## CSP 25-056 AL BP041 – ADDENDUM No.01 HVAC MEP EAST ZONE 3

Fort Bend Independent School District  
2023 Bond Program

Addendum 01

13 August 2025

SC-M3.01

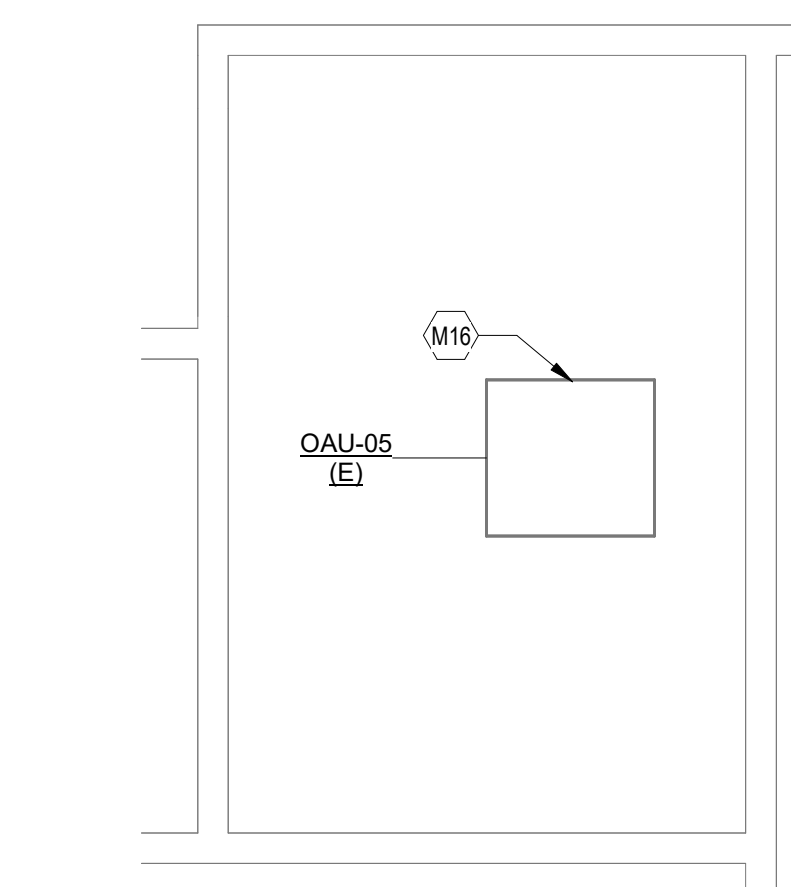
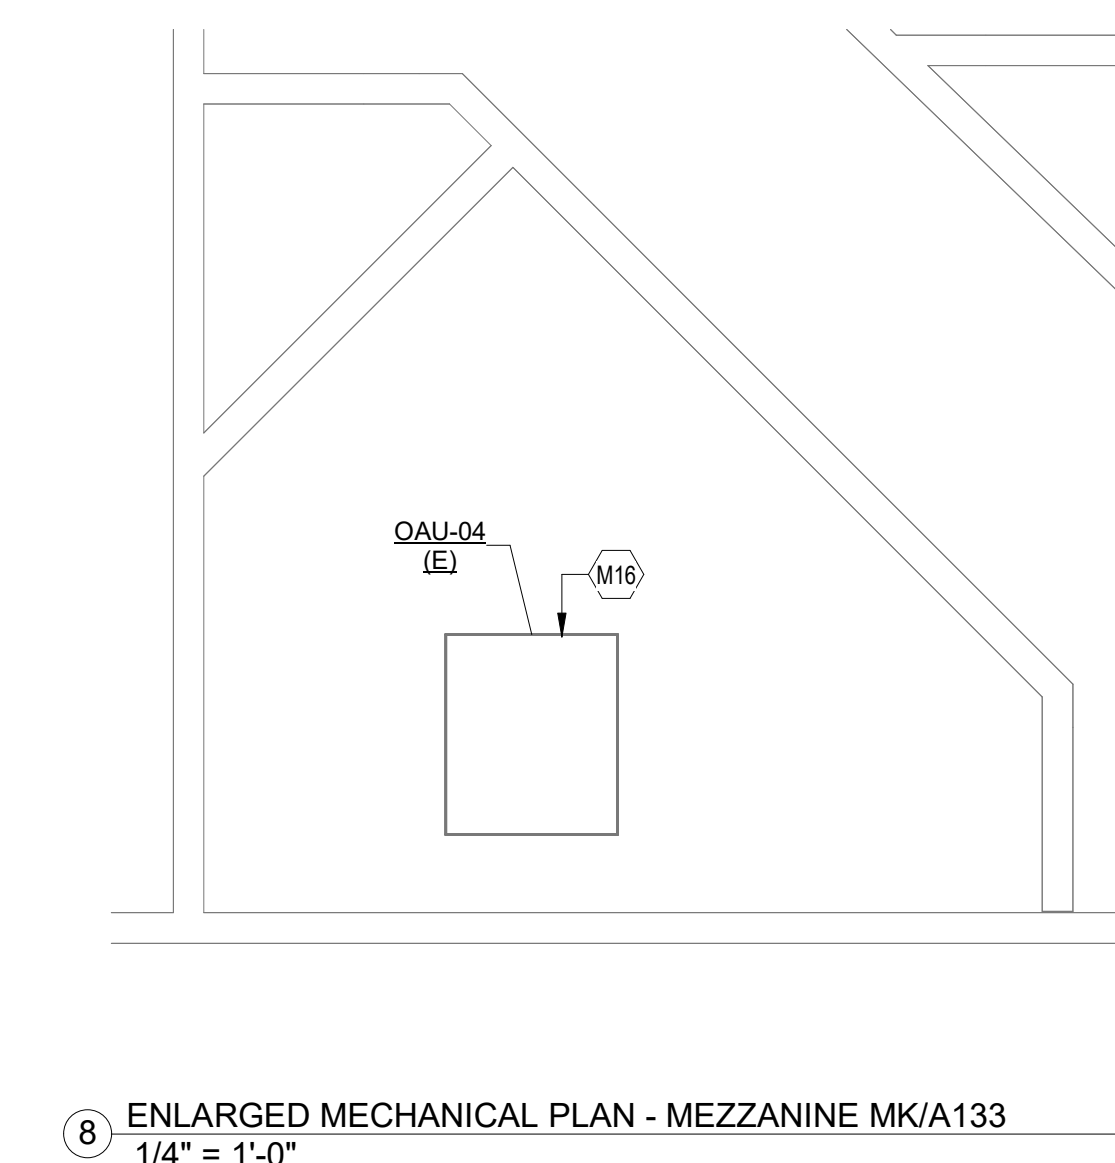
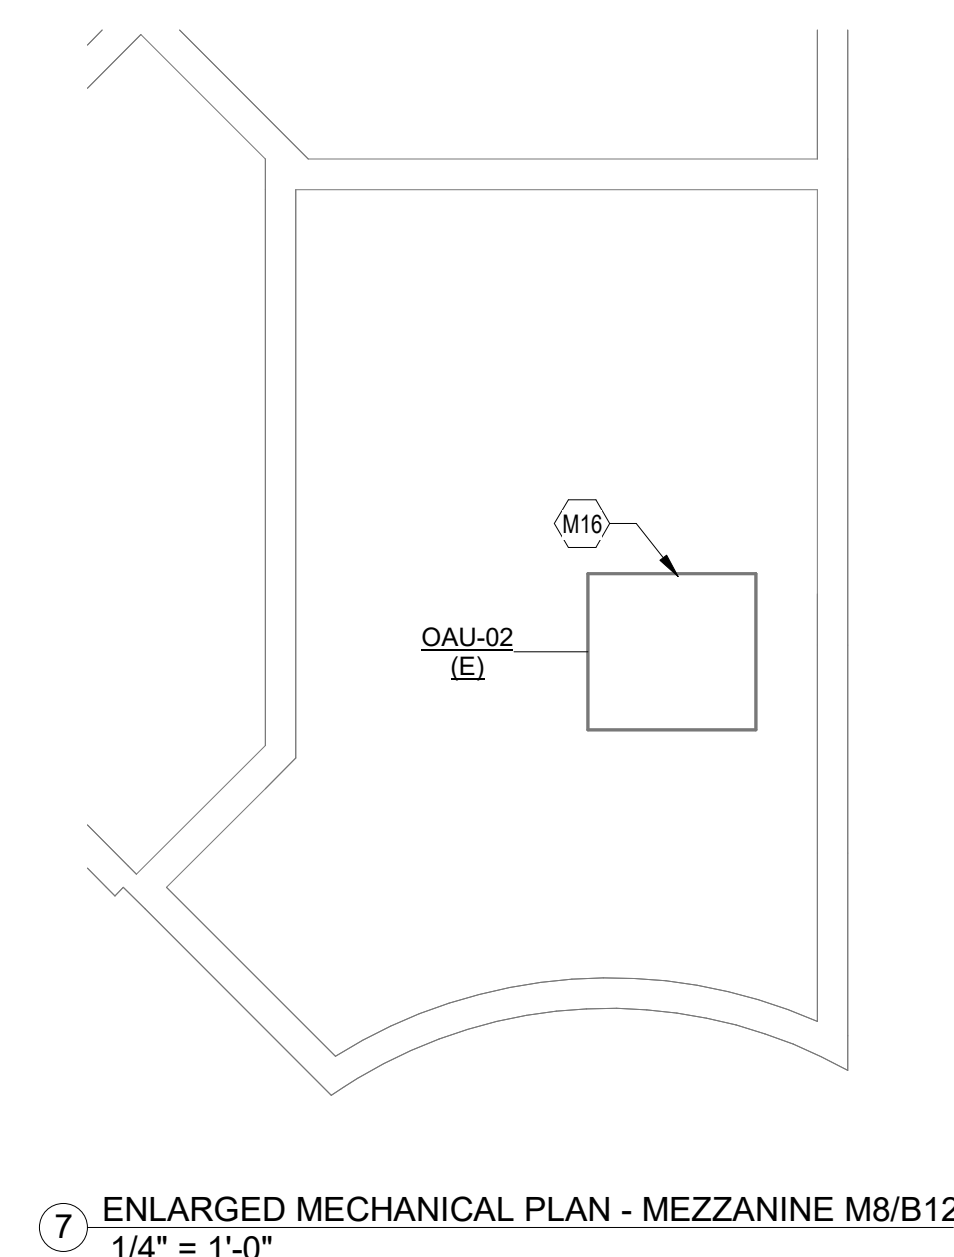
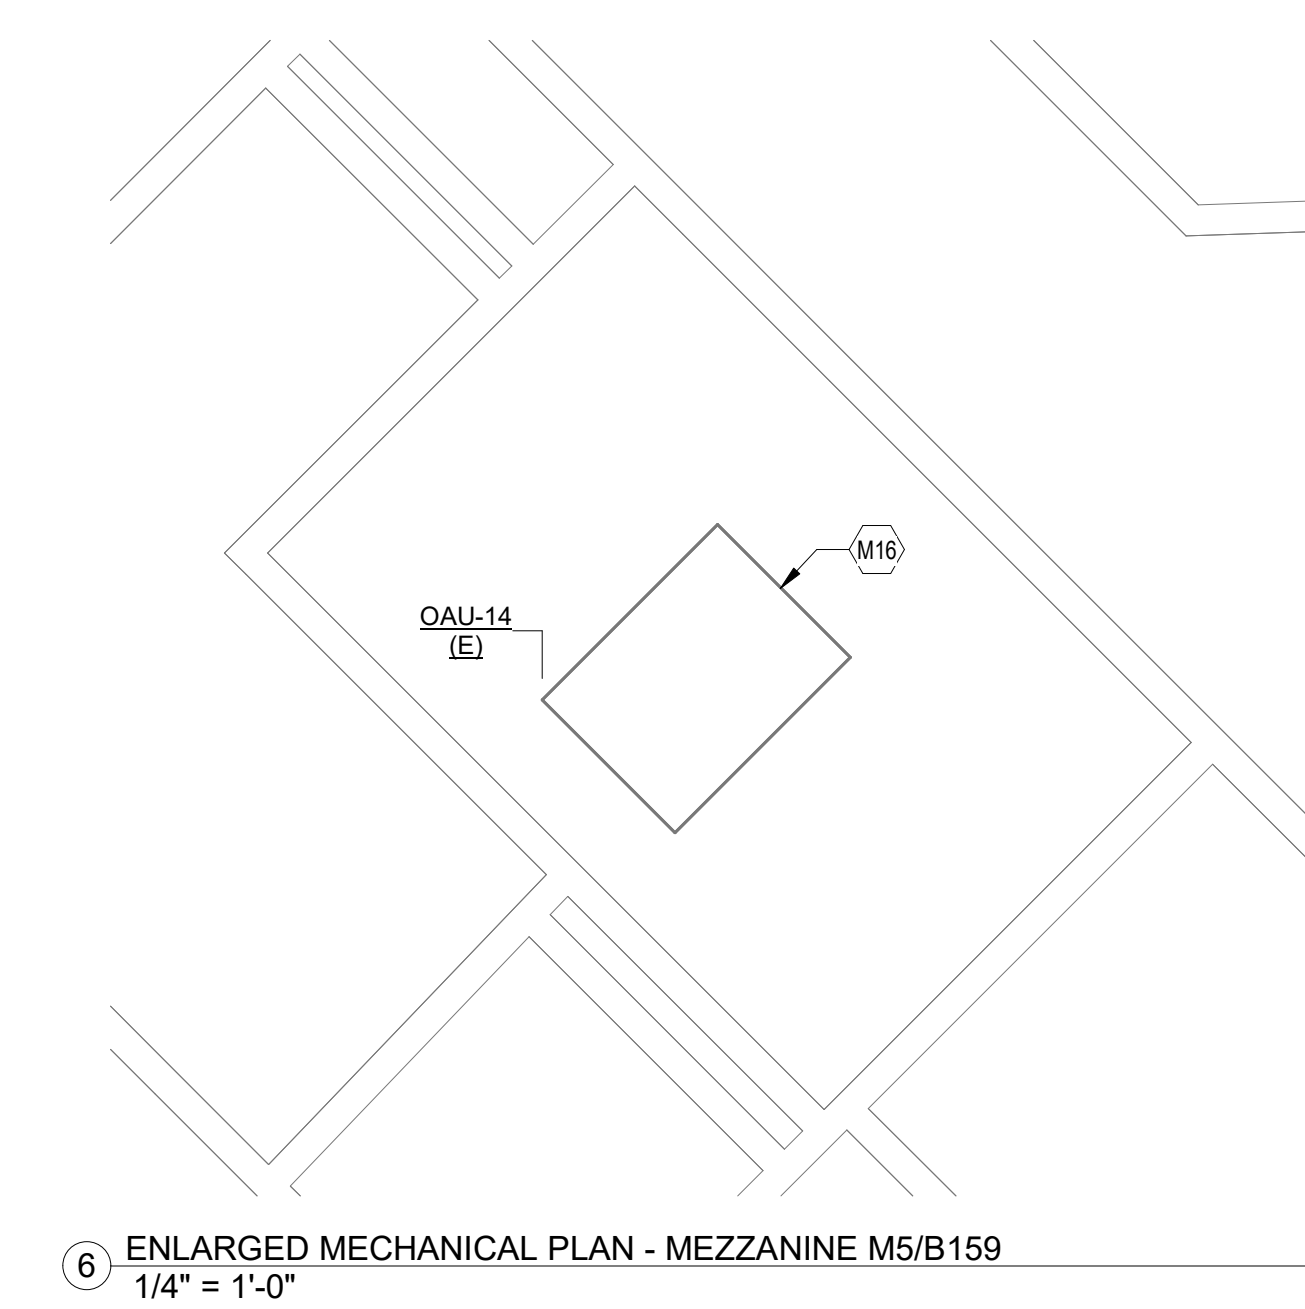
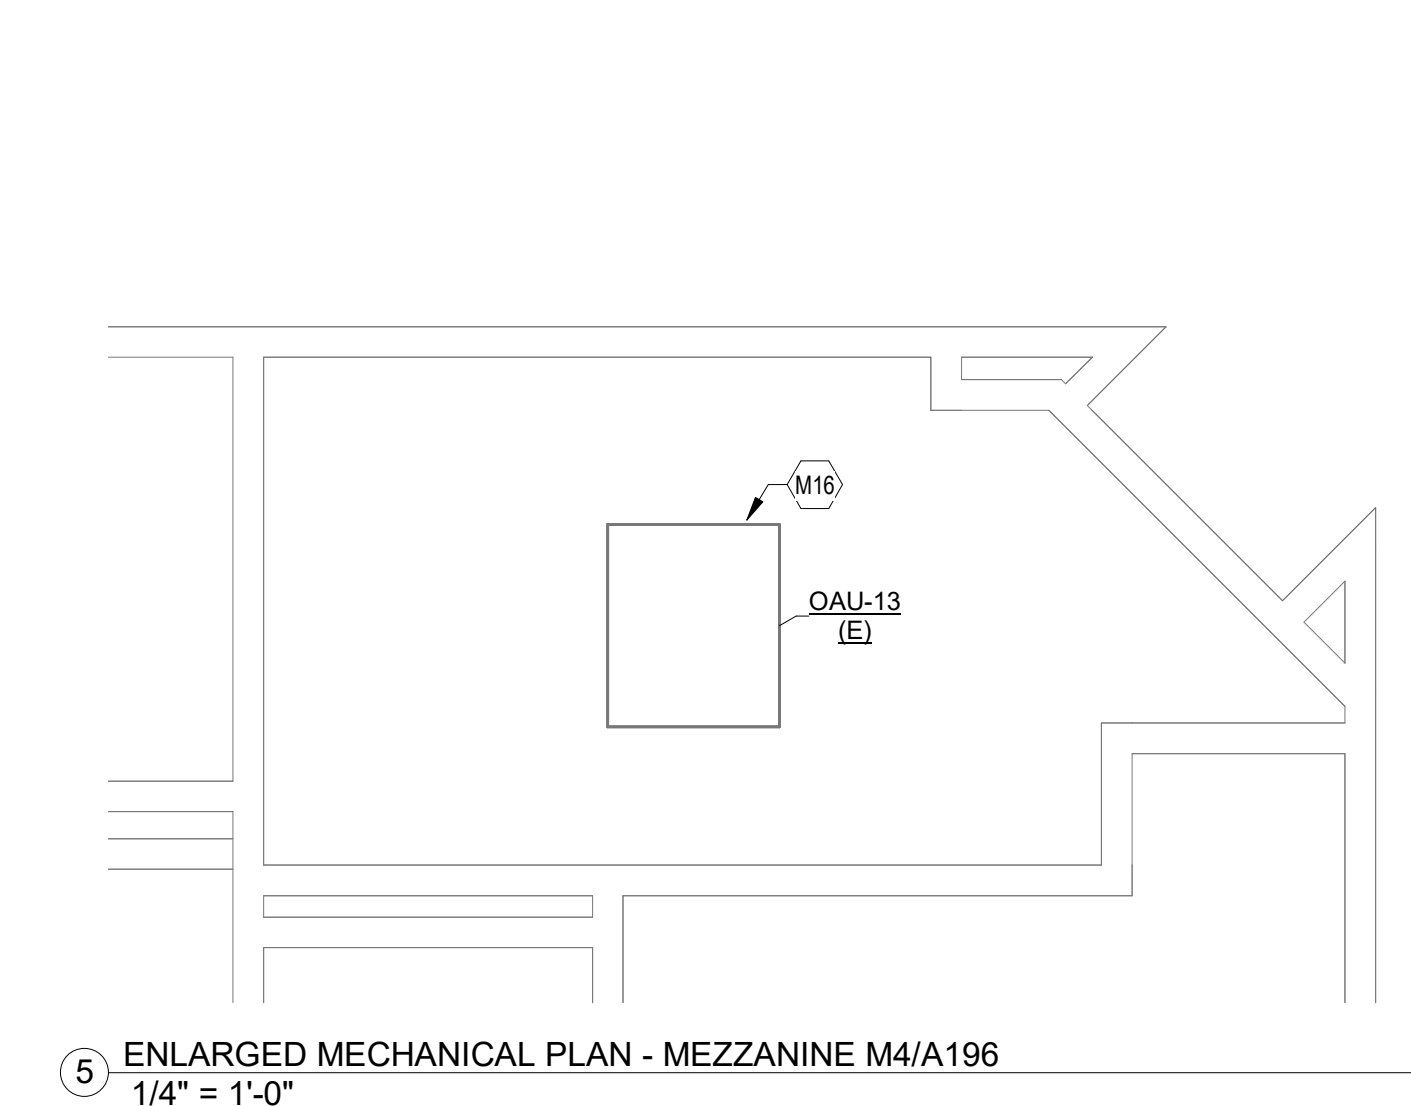
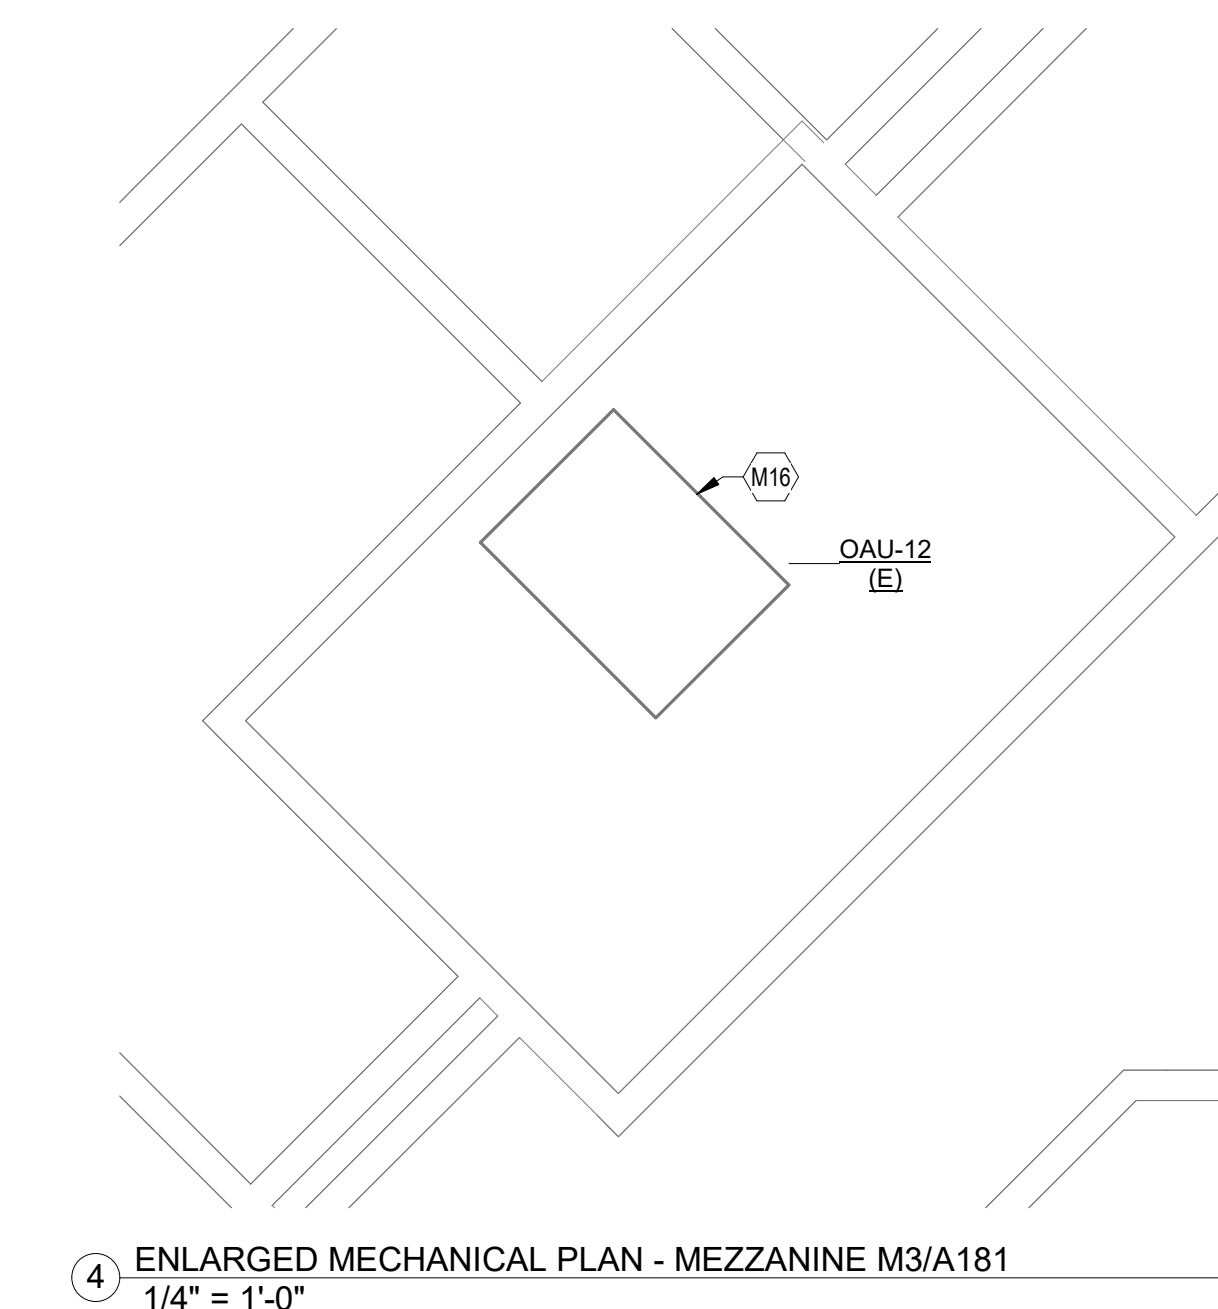
- 05 **Sheet SC-M3.01 – ENLARGED PLANS**
  - a. Changed sheet M3.01 to M3.02. Added new M3.01. Added keynote M16 to all mechanical platforms. “Install access panel in intake plenum of outdoor air unit. Install second access panel below OA discharge”

M16 INSTALL ACCESS PANEL IN INTAKE PLENUM OF OUTDOOR AIR UNIT. SIZE PANEL TO BE 30" BY DUCT WIDTH, MINUS FOUR INCHES. IF DUCT IS WIDER THAN 34", SIZE ACCESS PANEL UP TO 30"x30". INSTALL SECOND ACCESS PANEL ON UNIT FACE BELOW OA DISCHARGE. LOCATE ACCESS PANEL BELOW FAN SECTION FOR COIL ACCESS. DO NOT CUT ACCESS PANEL IN FAN SECTION. SIZE PANEL FOR 34" WIDTH BY 20" HEIGHT. REFER TO SPECIFICATIONS FOR UNIT PRICING.
